FLYING HORSE NORTH FILING NO. 3
CONSTRUCTION DOCUMENTS

AS-BUILT VERSION 1.0, DATED 7/15/2026
PE: RICHARD LYON
CO PE NO. 53921

FLYING HORSE NORTH FILING 3
PRI #2, LLC.
EL PASO COUNTY, CO

SHEET
PND

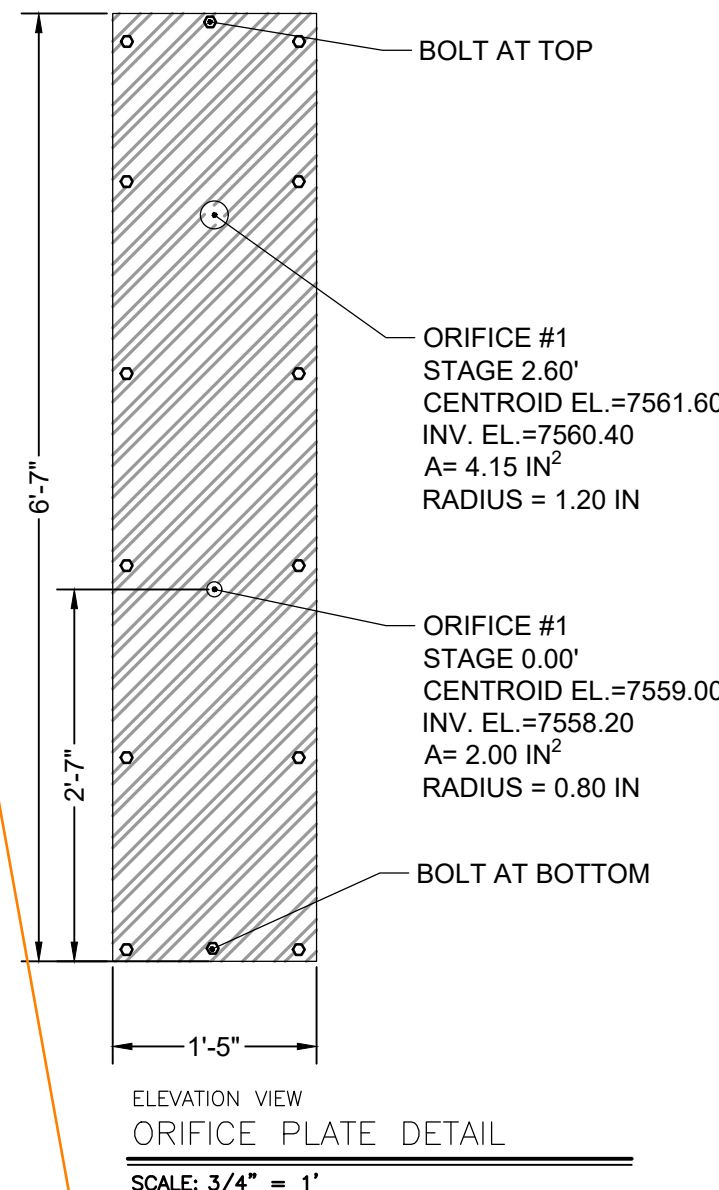
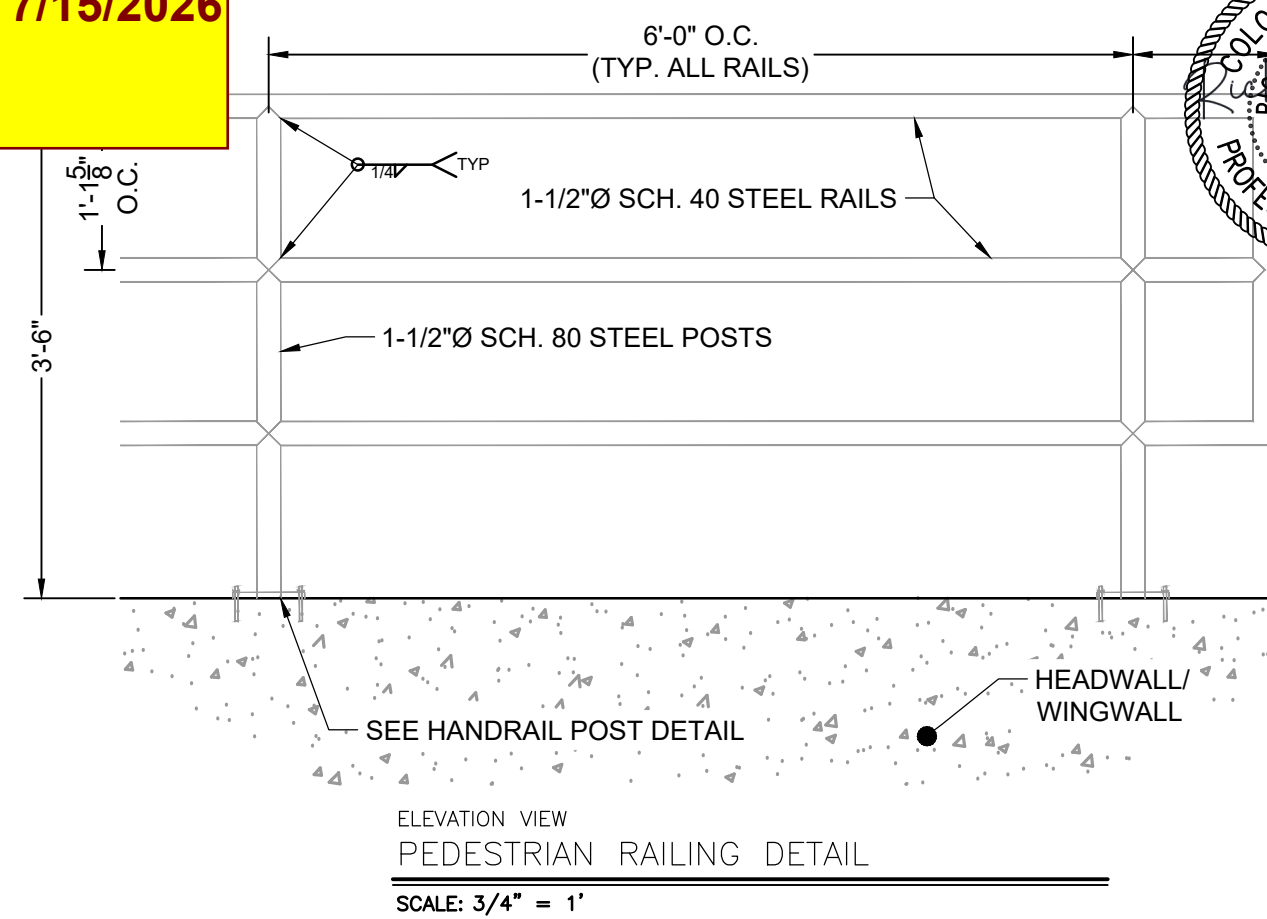
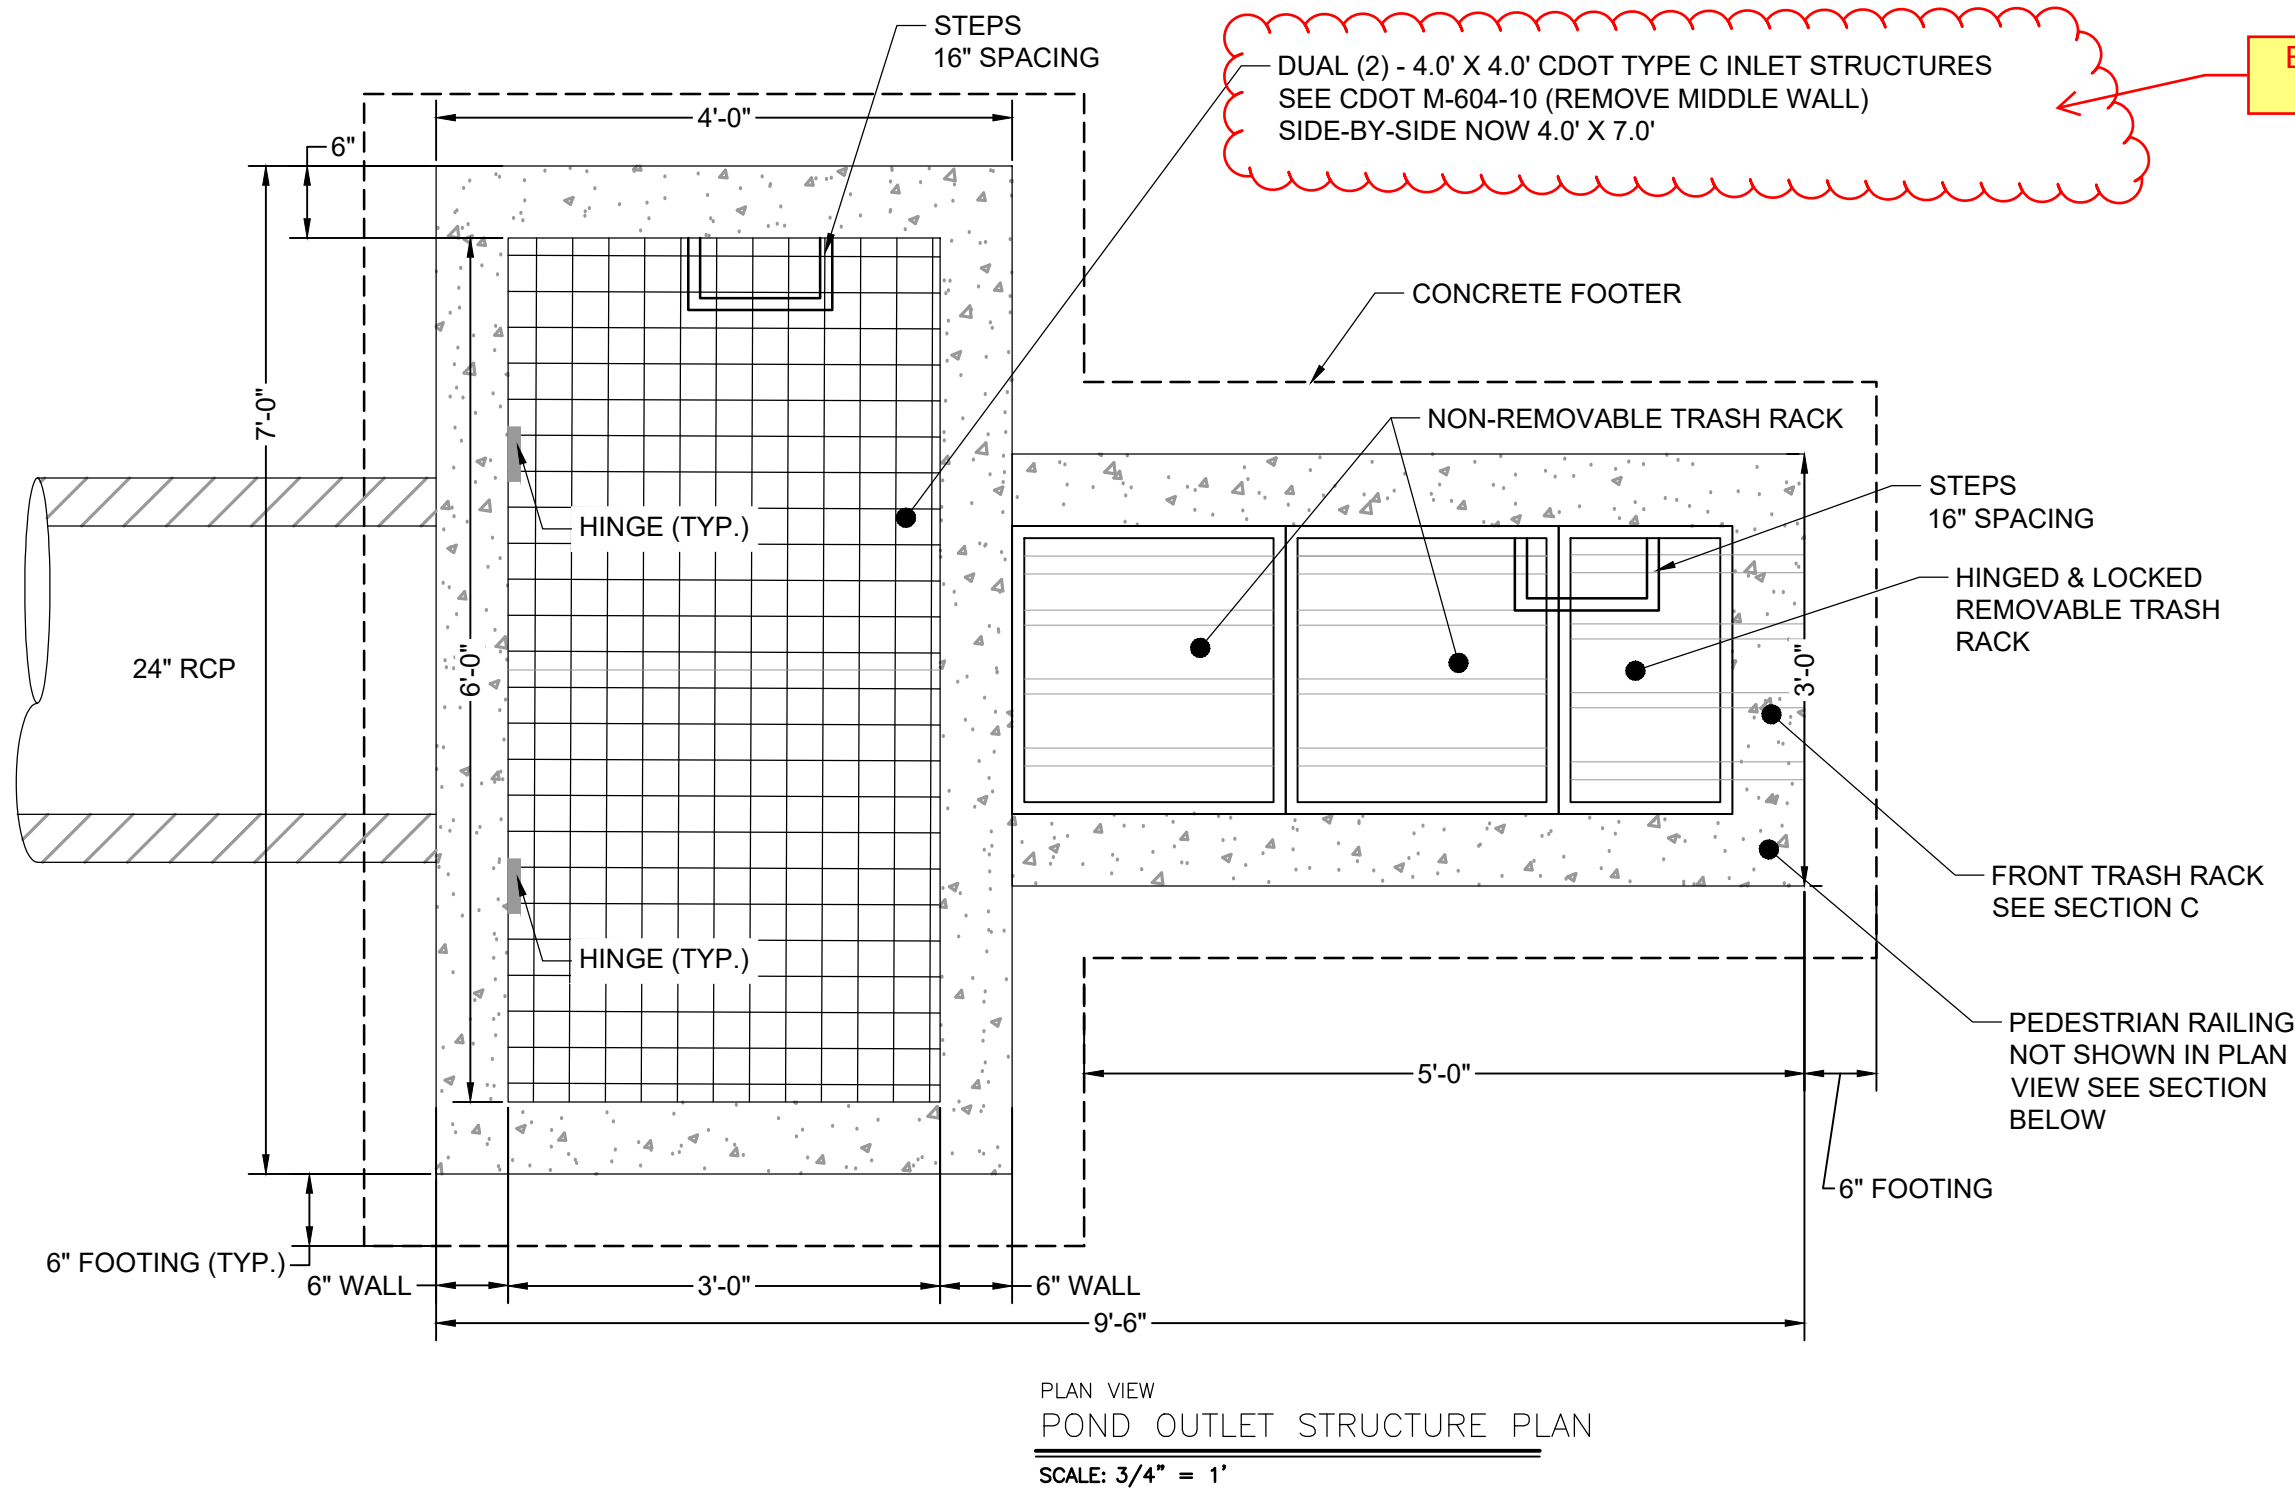
make as-built comment here too about the use of a bar grate

Has the work with CDR259 already taken place? If so, can you just show that as-built condition on here (but still notate that it was done per CDR259). I think it'd be cleaner to have a single set of as-builts for this pond instead of piecemealed across two projects.

what is going on over here with this? Add a new sheet if you need more space with as-built redlines.

NOW INSTALLED PER AS-BUILT ON SIGNAGE AND STRIPING PLAN.

ELEVATION VIEW
ORIFICE PLATE DETAIL
SCALE: 3/4" = 1'

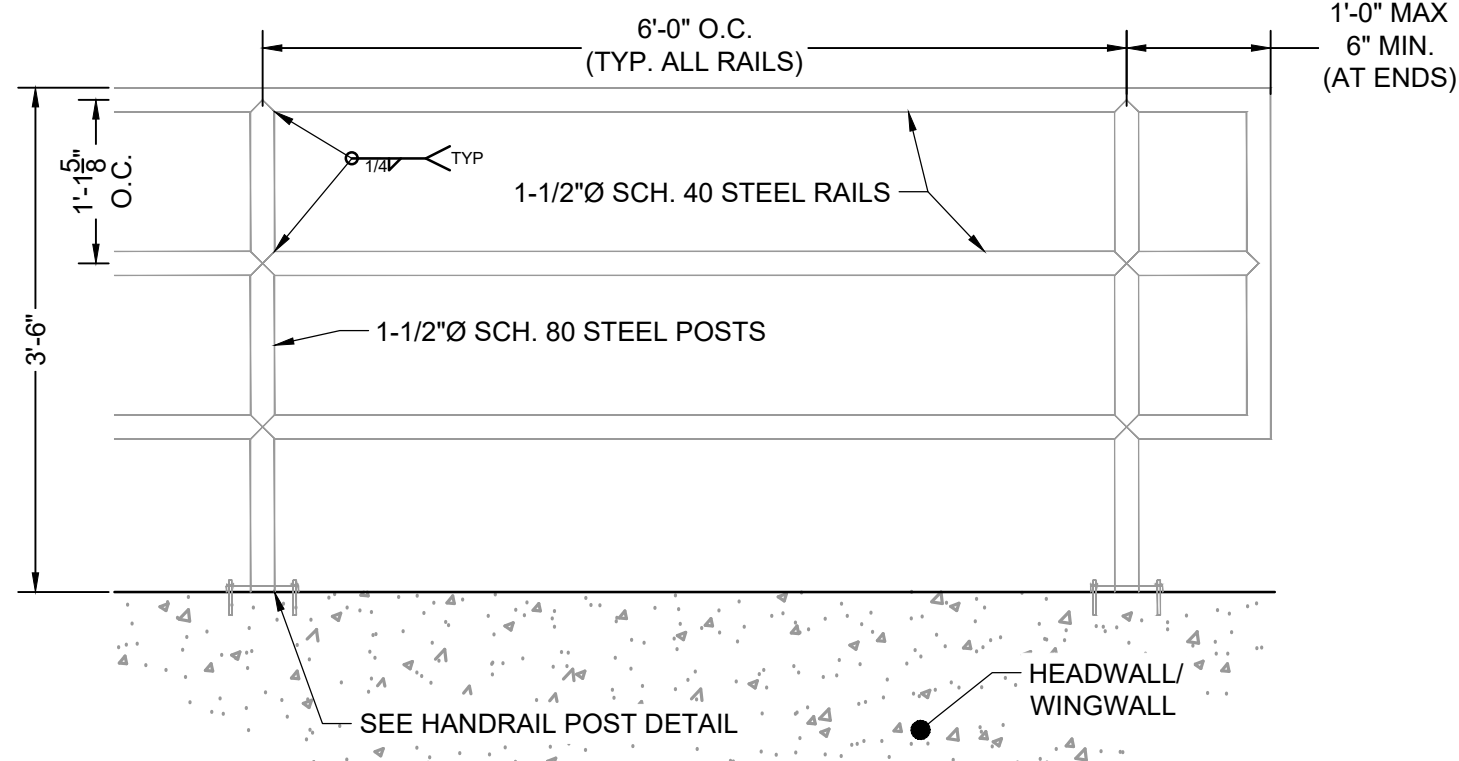
make as-built comment
here too about the use
of a bar grate

ORIFICE PLATE WAS REVISED PER AS-BUILT DATED SEPTEMBER 24, 2024.
REVISED PLATE CALLS FOR:
ORIFICE #1: STAGE 0 ORIFICE OF 1.98 SQ. INCHES (13/16" RADIUS)
ORIFICE #2: STAGE OF CENTROID @ 0.50 FT. FROM STAGE ZERO, SIZE OF 1.98 SQ. INCHES (13/16" RADIUS)
ORIFICE #3: STAGE OF 3.5 FT. FROM STAGE ZERO, SIZE OF 10 SQ. INCHES OR RECTANGULAR SLOT OF 6" WIDTH BY 1.67" HEIGHT.
